From: Scala, Mary Joy
Sent: Friday, March 10, 2017 12:40 PM
To: Steigman, Trey
Cc: Stephen von Storch (svonstorch@s-vs.com); Ryang, Eugene; Jessie Calder; Charlie Armstrong (CharlesA@southern-development.com); Steve Houchens
Subject: RE: WTP PUD PH2 - BAR COA - Submission for Administrative Approval

Re: William Taylor Plaza PUD-Phase 2-BAR COA Application-Administrative Review

WILLIAM TAYLOR PLAZA
BAR SUBMISSION
31 | JANUARY | 2017

LANDSCAPE PLAN

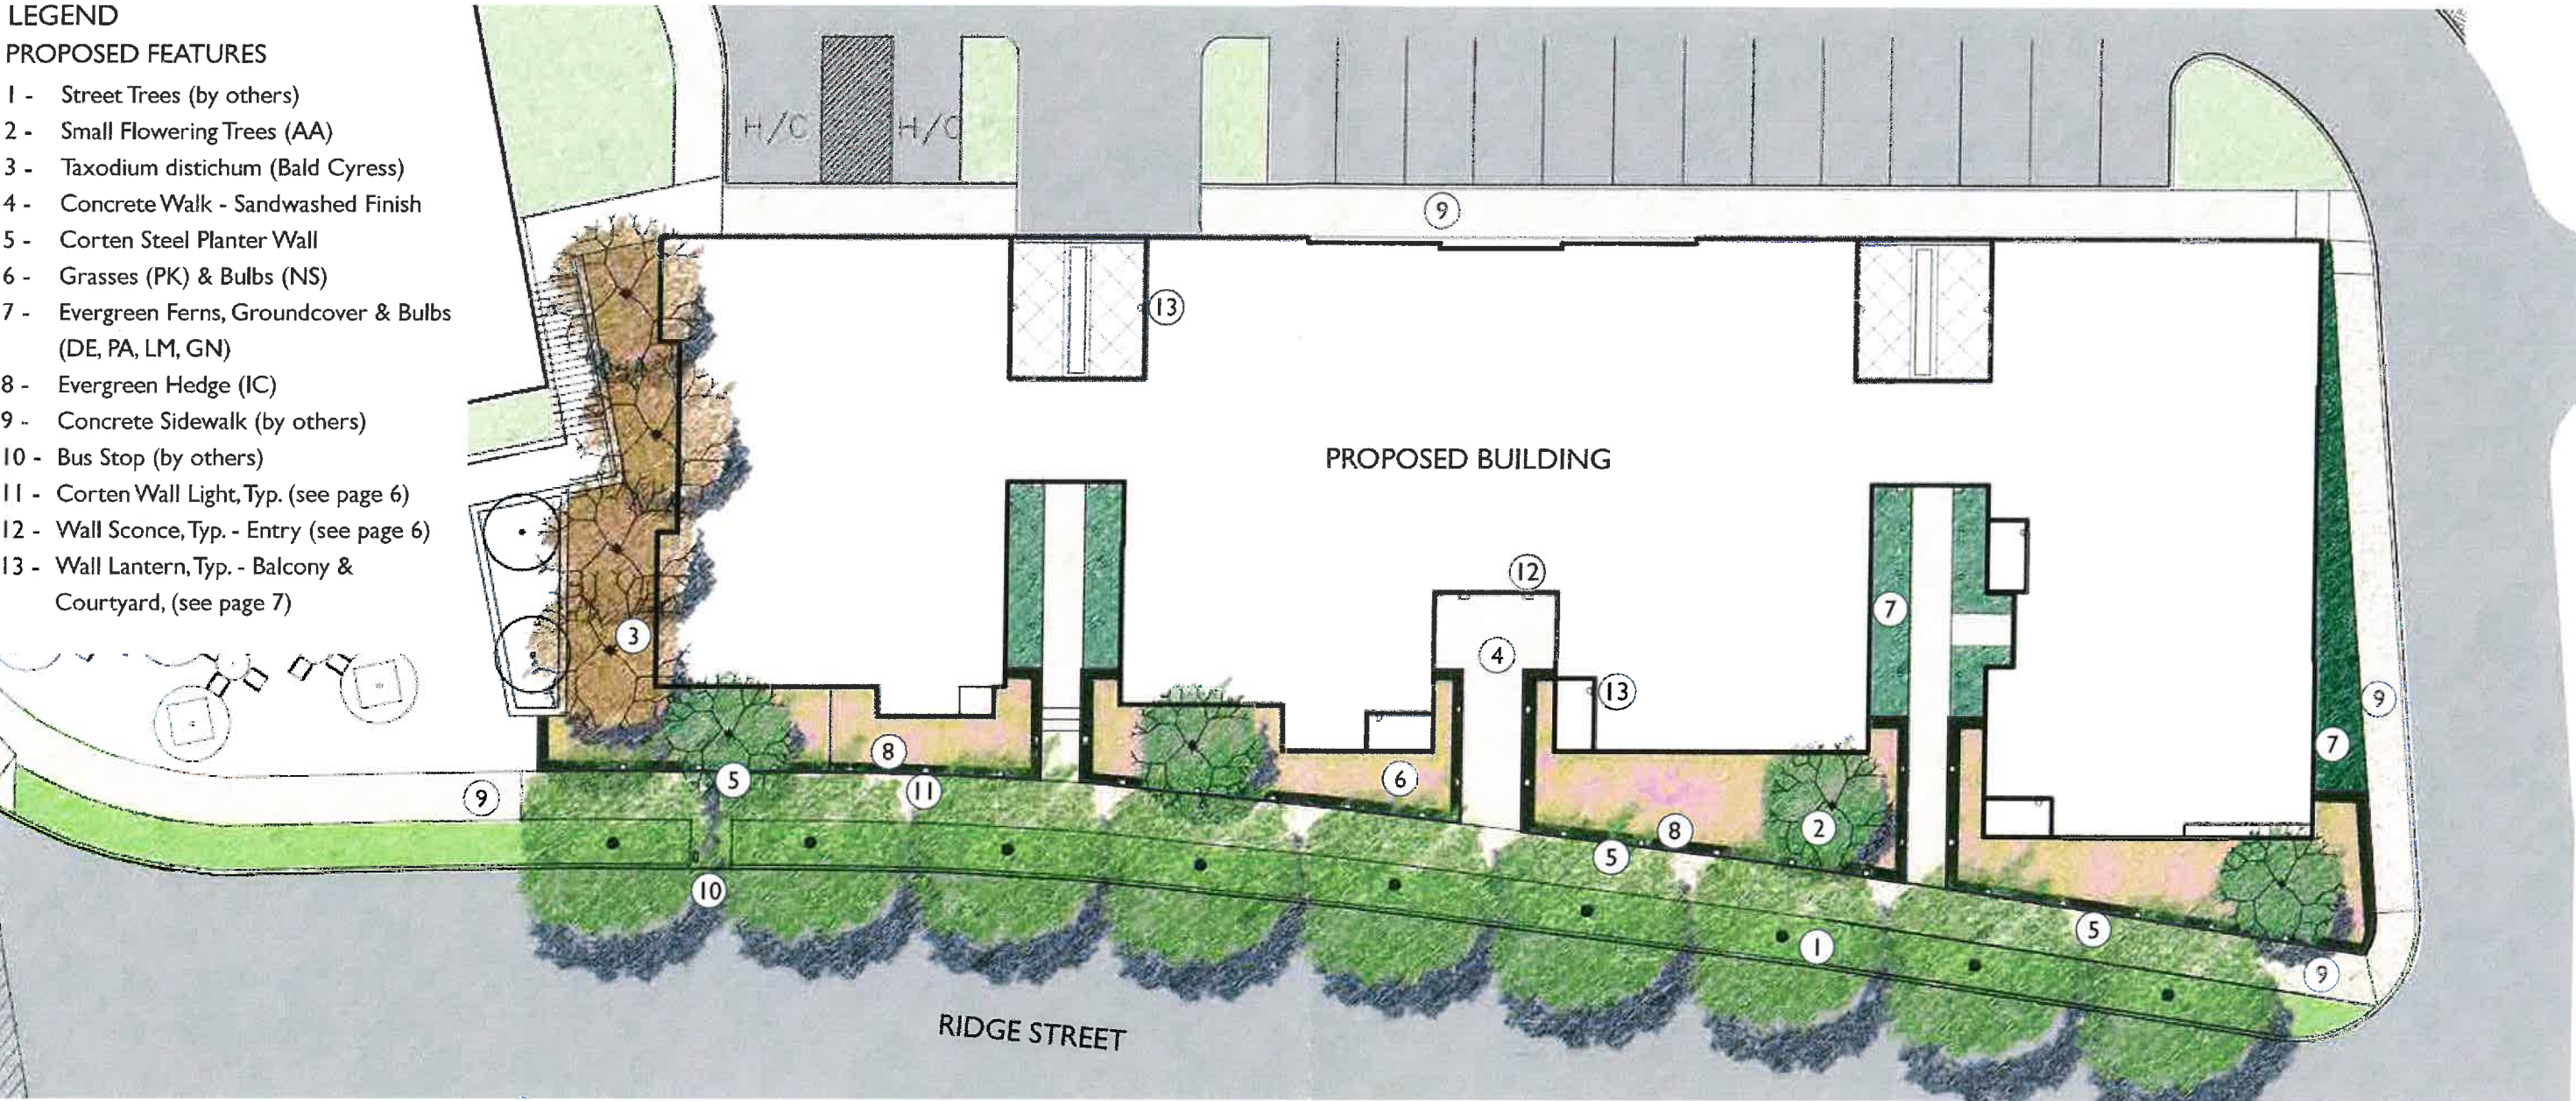
Schwartz moved to find that the landscape plan for the proposed new residential building satisfies the BAR's criteria and guidelines and is compatible with this property and other properties in the Ridge Street ADC district, and that the BAR approves the landscape plan as submitted and asks that the applicant give consideration to the trees on the south end of the building, and the BAR would like to approve administratively a final plan with every tree with its species, what lighting fixture will be used for the (exterior) porch balconies, and more details on the Corten wall (approve with the Corten wall turning the corner) and the BAR wants to see a Phase I site plan adjusted to match [this plan in the area of the plaza]. Clayborne seconded, and the motion passed 5-0.

Please review the attached drawing to see if it complies with your motion. Note that I still have not received a Phase I site plan that shows adjustments to match this project design.

I just received the fifth positive vote from the BAR for your revised landscape plan dated 31 January 2017, therefore it is approved, subject to there being no conflict with the site plan. I understand the site plan for William Taylor Plaza Phase 2 has not yet been submitted, but it should match the BAR's approved plan.
